NRC Technical Evaluation Report on Revised LTSP

SUBJECT: REVIEW OF DRAFT REVISED LONG-TERM SURVEILLANCE PLAN FOR THE
U.S. DEPARTMENT OF ENERGY FALLS CITY URANIUM MILL TAILINGS
DISPOSAL SITE, FALLS CITY, TEXAS

**TECHNICAL EVALUATION REPORT
DRAFT REVISED LONG -TERM SURVEILLANCE PLAN
FOR THE U.S. DEPARTMENT OF ENERGY
FALLS CITY URANIUM MILL TAILINGS DISPOSAL SITE,
FALLS CITY, TEXAS**

FACILITY: Falls City Uranium Mill Tailings Disposal Site, Falls City, Texas

Figure 2. Ground Water Monitor Wells at the Falls City Disposal Site (Figure 2-5 from DOE, 2006a)

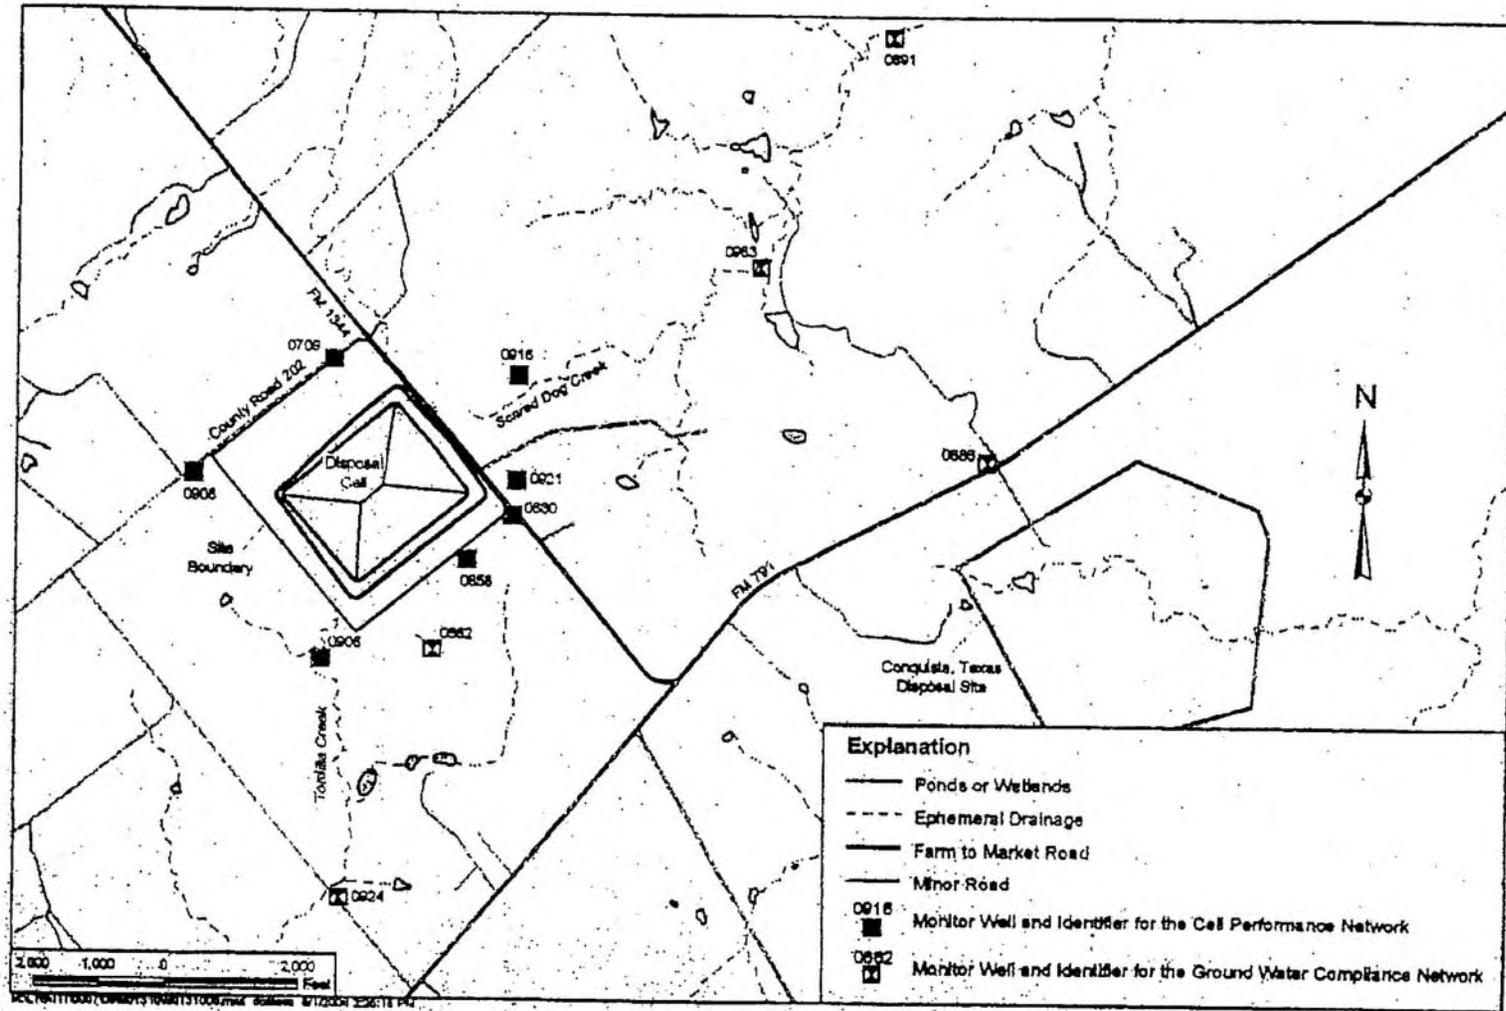
The performance cell monitoring and the GCAP monitoring wells are delineated in Figure 2. The performance cell monitoring network consists of 7 wells (0709, 0858, 0880, 0906, 0908, 0916, and 0921) surrounding the disposal cell and screened in the Deweesville and Conquista aquifer. Monitor wells 0908 and 0916 are located updip of the intersection of the typical water table and the bottom of the Deweesville and Conquista aquifer; therefore, these wells are usually dry. Ground water samples are collected biannually from these wells, and they are analyzed for the analytes listed in Table 1 (DOE, 1997b and DOE, 2006b).

The ground water compliance network consists of 5 monitor wells (0862, 0886, 0891, 0924, and 0963) located downgradient from the identified affected areas (Figures 3 and 4). Monitoring wells 0886, 0924, and 0963 are screened in the Deweesville and Conquista aquifer, and monitoring wells 0862 and 0891 are screened in the Dilworth aquifer. Ground water samples are collected annually from these wells, and they are analyzed for the analytes in Table 1 (DOE, 1997b and DOE, 2006b).

Figure 3. Ground Water pH in the Deweesville and Conquista Aquifer (Figure 2-7 from DOE, 2006a)

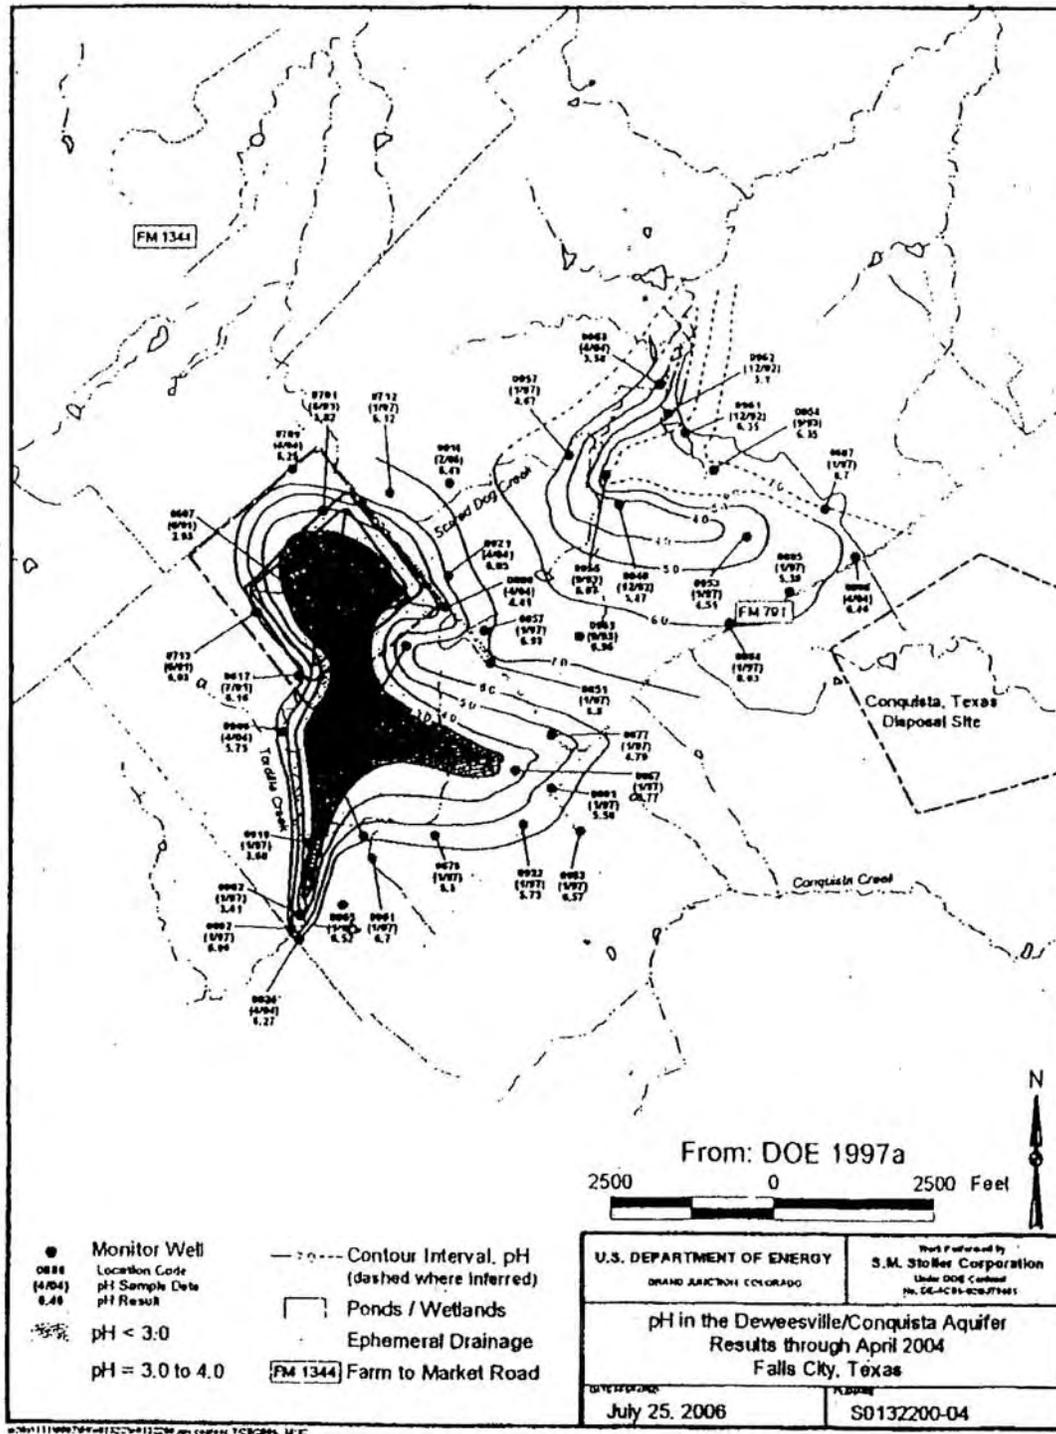
Figures 3 and 4 delineate the pH in the Deweesville and Conquista aquifer and Dilworth aquifer, respectively. The pH isopleths on these figures are surrogates for uranium and some of the other metals listed in Table 1. Figure 3 shows that there are two areas of lower pH, which would represent uranium plumes in the Deweesville and Conquista aquifer. Figure 4 indicates that there is one area of lower pH, which would represent a uranium plume in the Dilworth aquifer.

Figure 4. Ground Water pH in the Dilworth Aquifer (Figure 2-8 from DOE, 2006a)

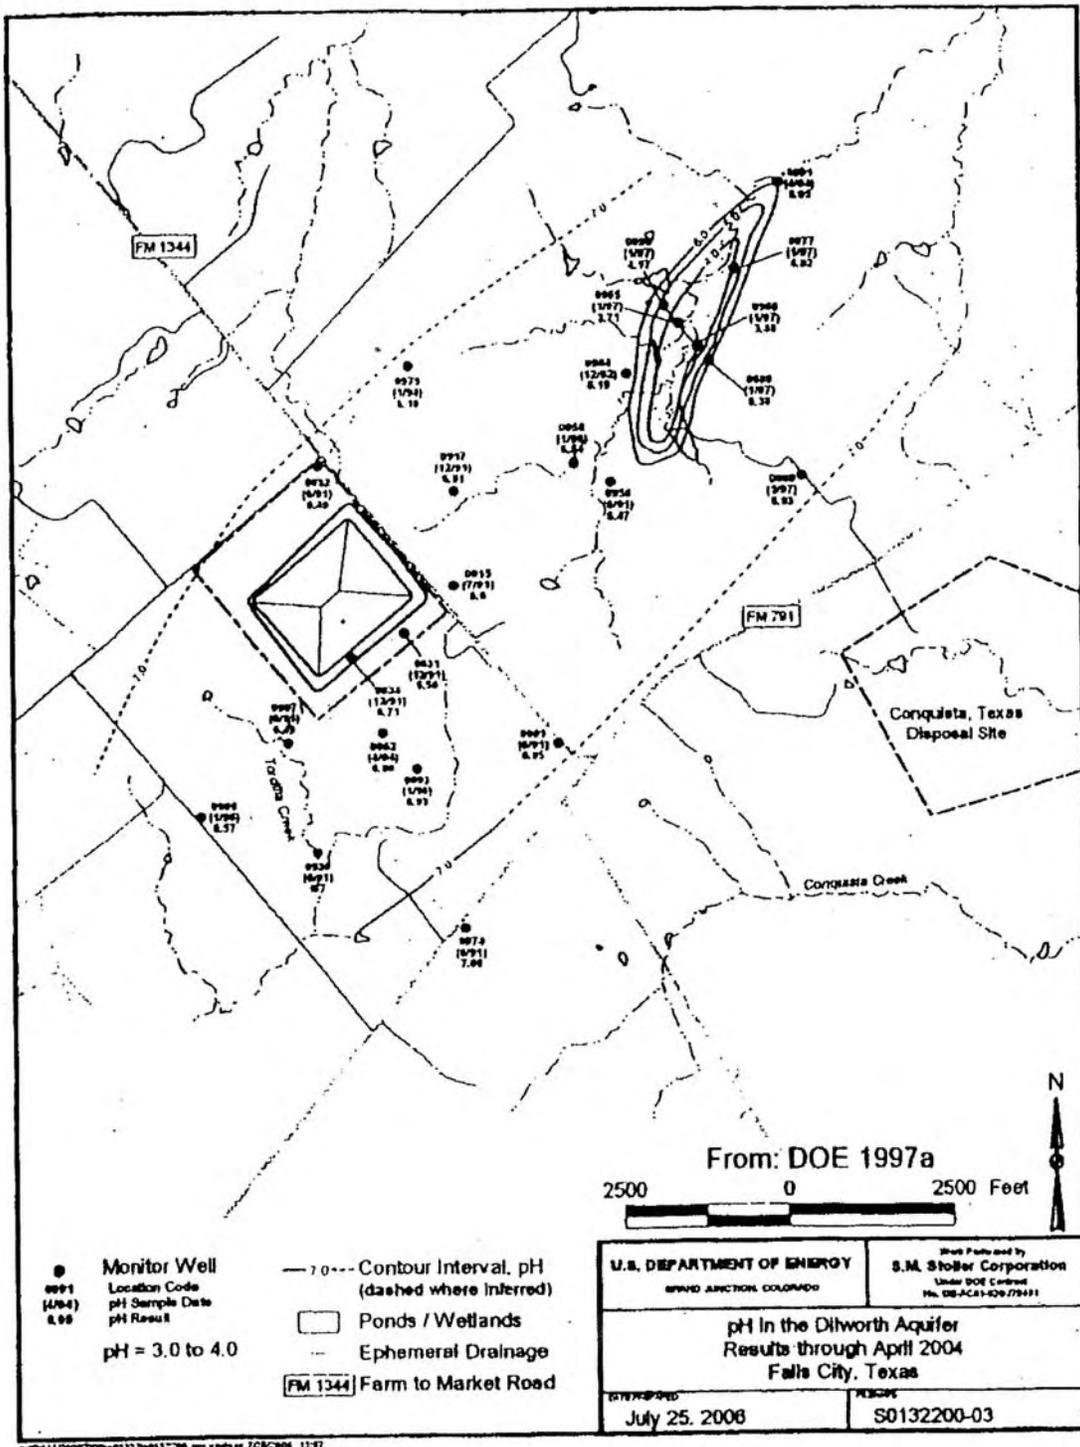
Well 0891 has variable gross alpha values and uranium concentrations with a significant increase in uranium from 0.05 to 0.45 mg/L from May 2005 to May 2006. It should be noted that due to overgrown vegetation, Well 0891 was not identified or sampled during DOE's April 2007 sampling event (Ransbottom, 2007); however, uranium in an October 2007 ground water sample of this well was 0.033 mg/L (Maestas, 2008). The earlier increase in uranium in Well 0891 presents a concern because this well is located along the front of the pH plume, the surrogate uranium plume (Figure 4). As discussed above, ground water from the Dilworth aquifer is not used as a source of domestic or drinking water within 2 miles of the site; however, Well 0891 is located about 1.7 miles from the site. Reportedly, use of the Dilworth aquifer downgradient of Well 0891 is for livestock watering or gardening.

Based upon NRC staff review of the revised draft LTSP and supporting documents, the NRC concurs with the DOE proposed revisions contained in the draft LTSP. In addition, based upon recent uranium concentration trends in Well 0891, the NRC staff believes that the DOE should continue to monitor uranium trends in Well 0891.
